STAFF RECOMMENDATION
2302 Belmont Boulevard
August 15, 2018

Application: New Construction—Addition and Outbuilding
District: Belmont-Hillsboro Neighborhood Conservation Zoning Overlay
Council District: 18
Map and Parcel Number: 10416037300
Applicant: Manuel Zeitlin Architects
Project Lead: Sean Alexander, sean.alexander@nashville.gov

Description of Project: The proposal is to enlarge the house with a two story rear addition and to construct an outbuilding behind the house. The addition will be shorter and narrower than the existing building. The outbuilding may be used as a Detached Accessory Dwelling Unit.

2302 Belmont Boulevard, front.

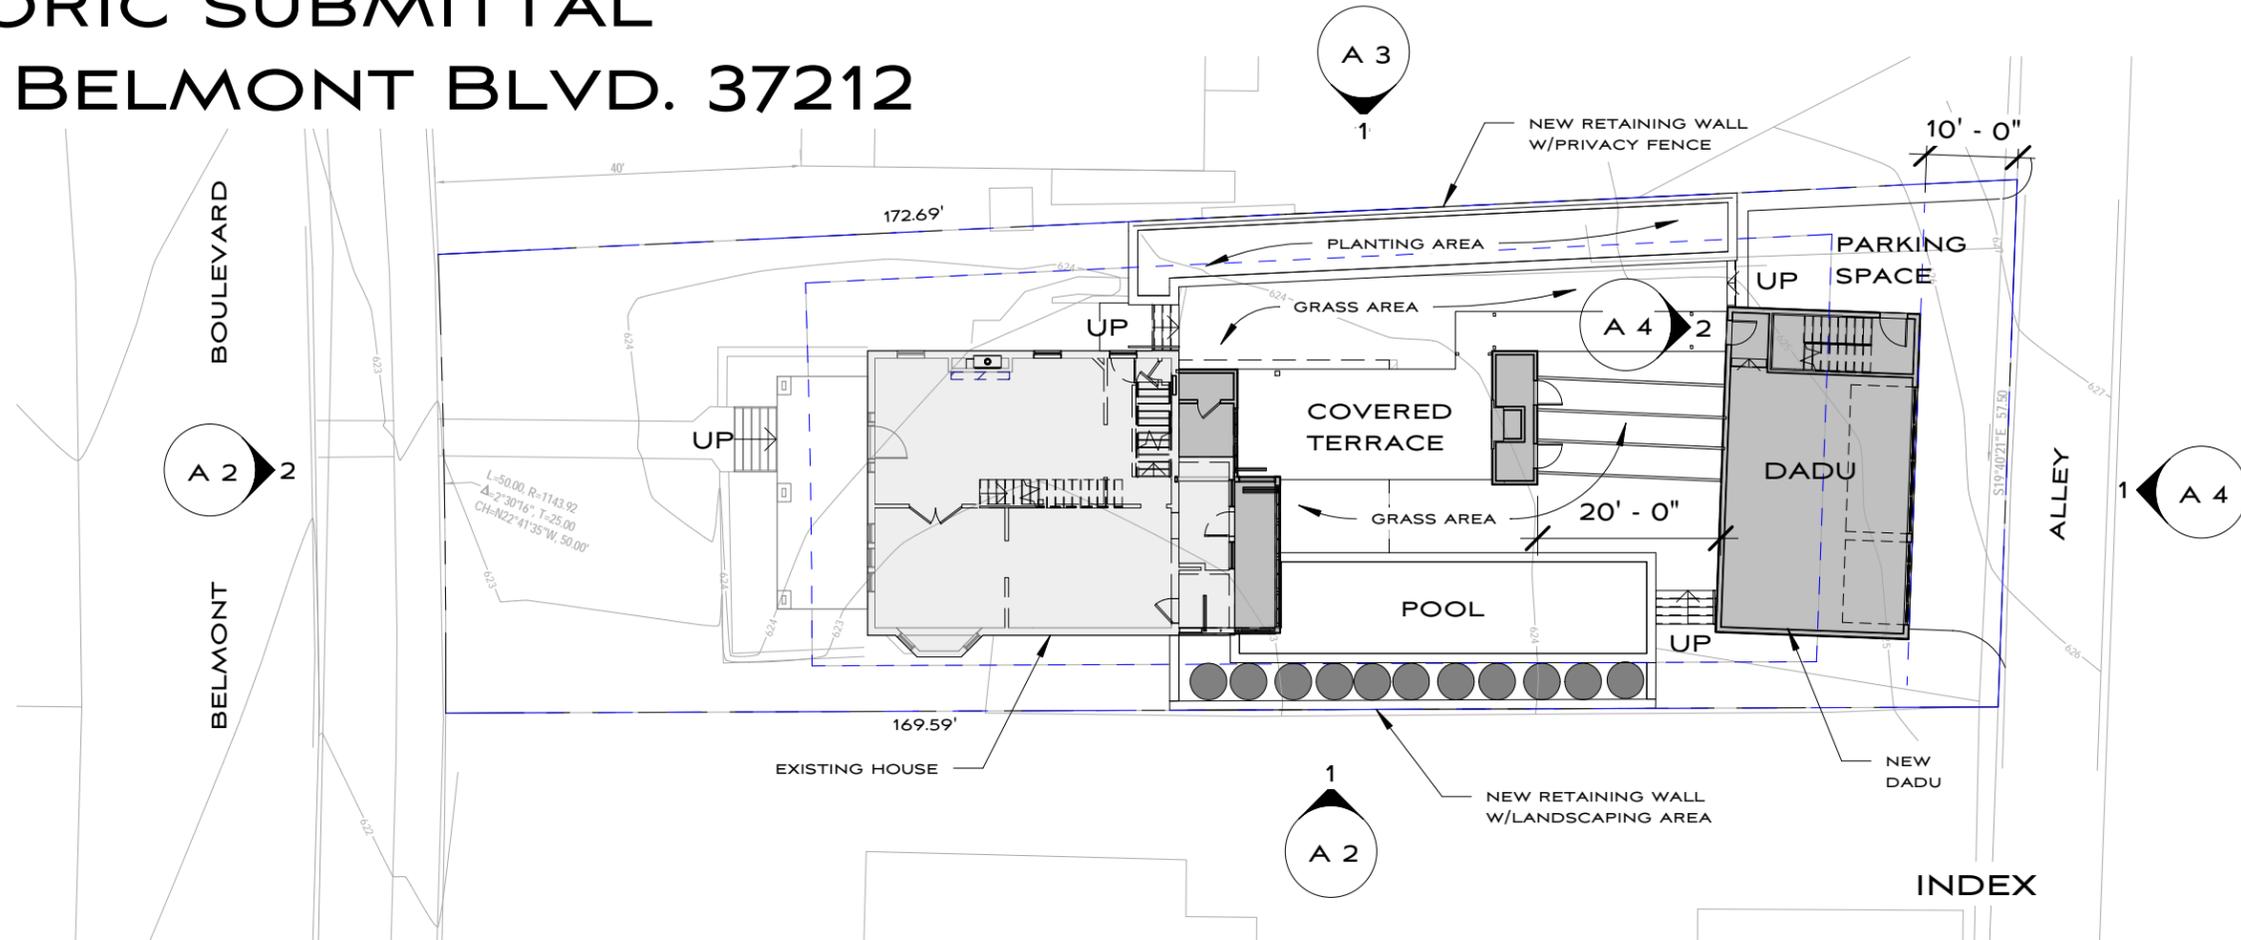
Background: The house at 2302 Belmont Boulevard is a two and one-half story American Foursquare style house, constructed circa 1920. The house is primarily brick, with a stone foundation and rusticated stone front porch columns.

1 SITE PLAN
1" = 20'-0"

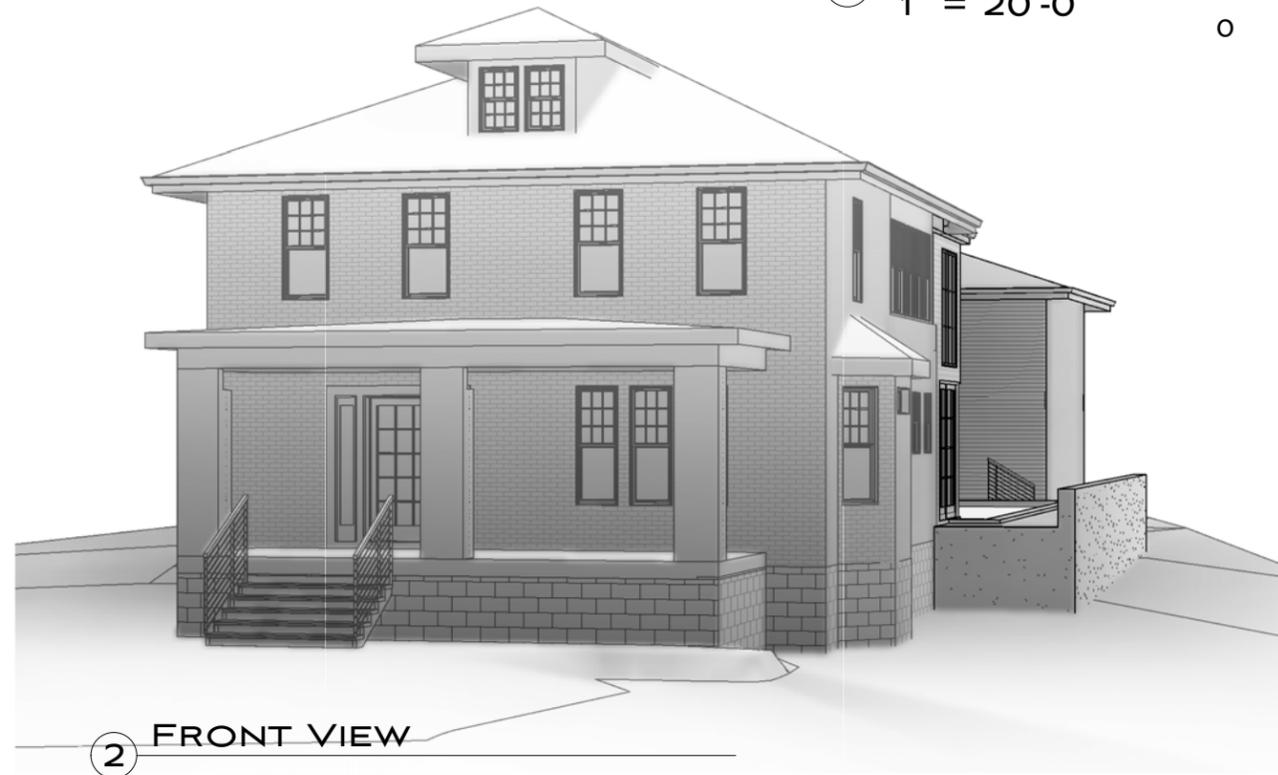
Appurtenances & Utilities: The project includes an outbuilding, described below, with a parking area and a driveway at the rear of the lot which is an appropriate location. The location of the HVAC and other utilities was not noted. Staff asks that the HVAC be located on the rear façade, or on a side façade beyond the midpoint of the house. With that condition, Staff finds that the project meets section II.B.1.h of the design guidelines.

MINIMUM	PROPOSED
Space between principal building and DADU/Garage	20’	20’
Rear setback	5’	10’, 7’ from balcony
L side setback**	5’	13
R side setback**	5’	7’
How is the building accessed?	From the alley or existing curb cut	Alley

① SOUTH ELEV
1/8" = 1'-0"

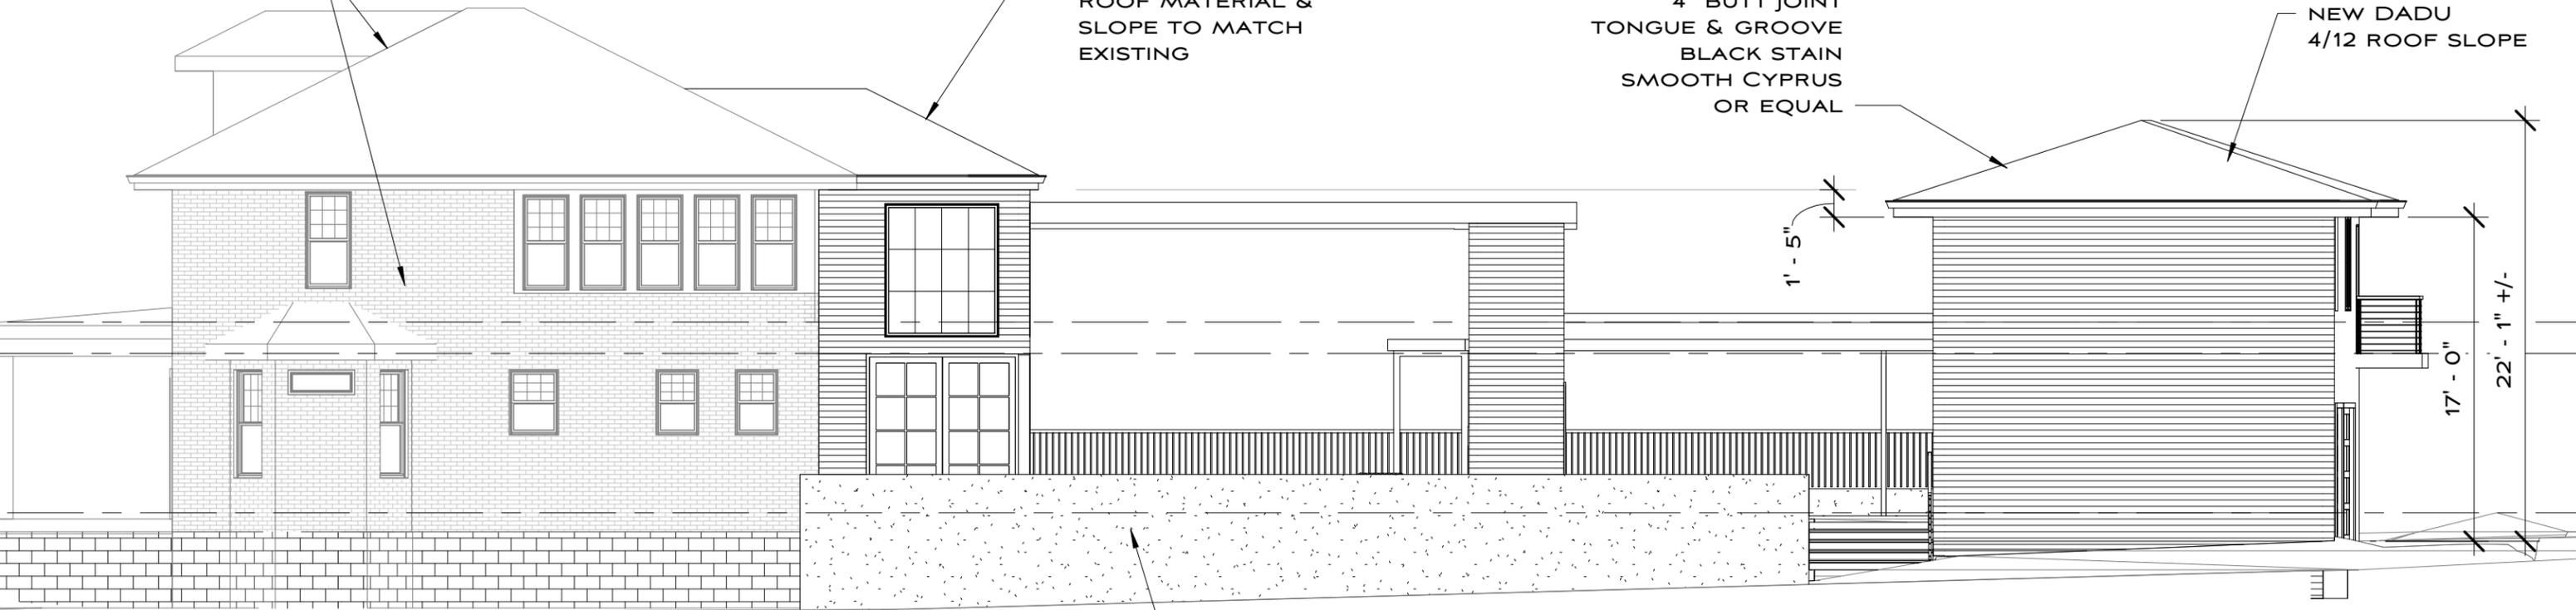
Height & Scale: The hipped roof component of the addition will tie into the rear slope of the existing roof, matching its pitch and form but with a shallower eave overhang that allows it to sit off of the original roof form and keep it intact. The peak of the hipped roof will be four feet (4') shorter than the historic house's roof, with the eaves matching the height of the existing eaves. This section of the addition will extend eleven feet (11') toward the rear.

The flat roof component will tie into the rear wall of the house approximately one foot (1') below the existing eaves, ten feet (10') lower than the peak of the primary roof, and will extend twenty-eight feet (28') further than the hipped roof section of the addition for a total depth of thirty-nine feet (39'). The historic house, including its original nine foot (9') deep front porch, is forty-three feet (43') deep. This component of the addition will be a roof only, with no side walls.

Roof form: The addition's hipped roof will have a pitch of 6:12 to match that of the existing house. The flat roof section is not at all like that of the existing building and is not typical of historic houses in the area, but it will not be greatly visible because it is located behind the primary mass of the building and stepped in from the left side. Staff finds that the project meets section II.B.1.e of the design guidelines.

① LEVEL 1 - PROPOSED
1/8" = 1'-0"

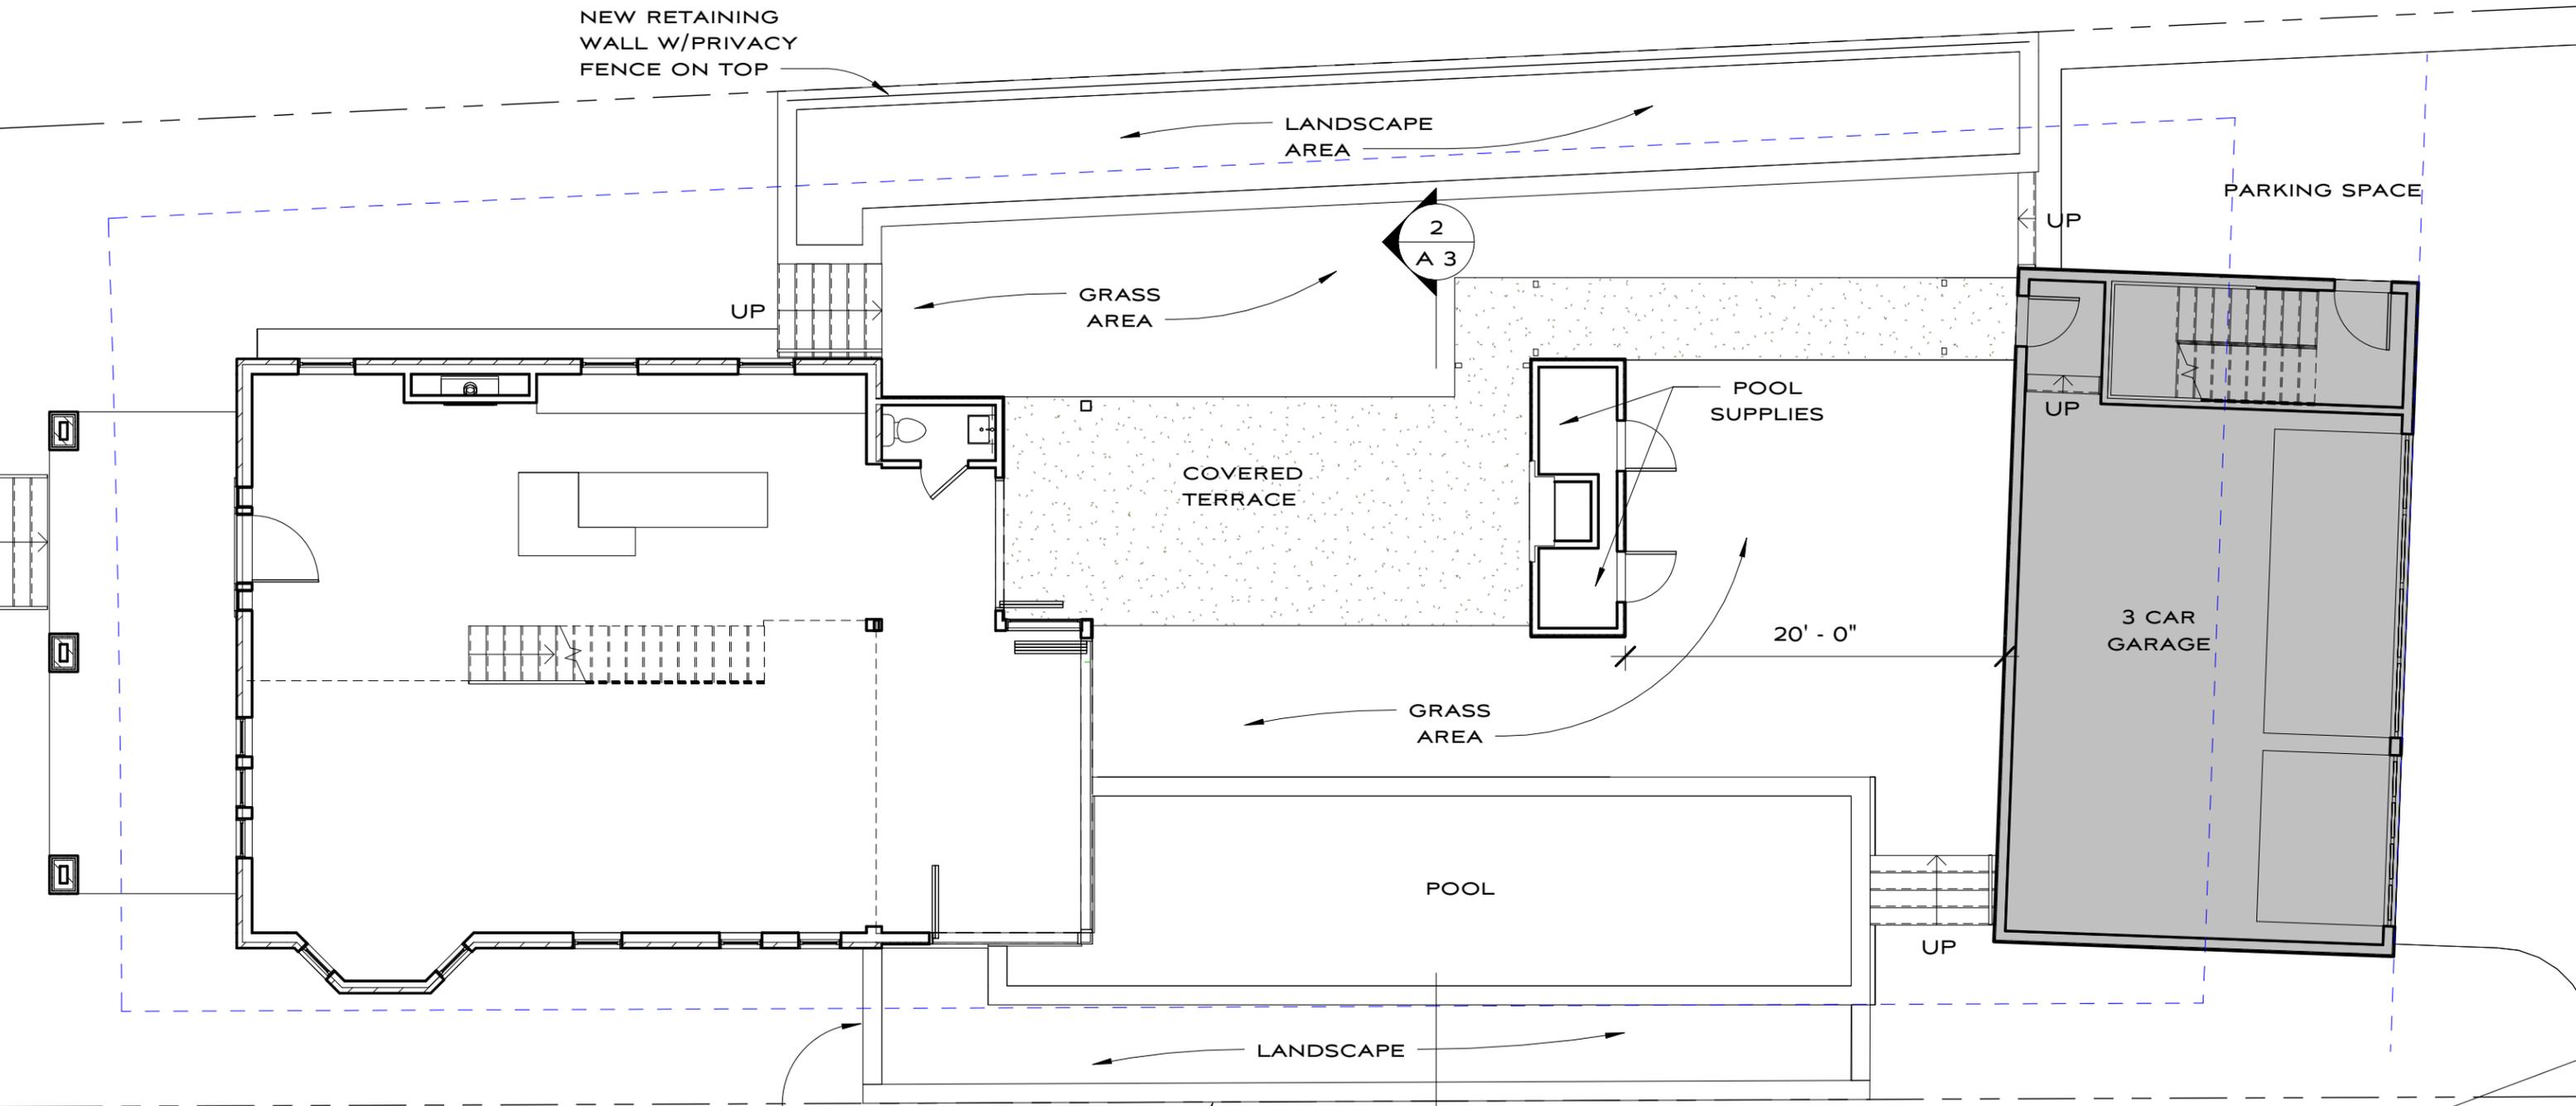
The hipped roof section of the addition will be on the right half of the rear of the building, tying in to the back-right corner of the house. The addition will be clad with a different exterior material than the existing house, with the right side wall stepping in the width of the brick veneer, approximately four inches (4"). Typically two story additions would be required to step in two feet (2') in order to differentiate it from the historic building and to preserve the original building's form. Here, the original form has already

The flat-roofed section will be toward the left side of the building, and will be stepped in two feet (2') from the left side of the historic house. This location is appropriate. Staff finds that the location of the addition at the rear of the building, with no impact to the front or sides of the historic house, is appropriate and could be reversible without further affecting the historic integrity of the building. Staff finds that the project meets sections II.B.2.a and II.B.2.e of the design guidelines.
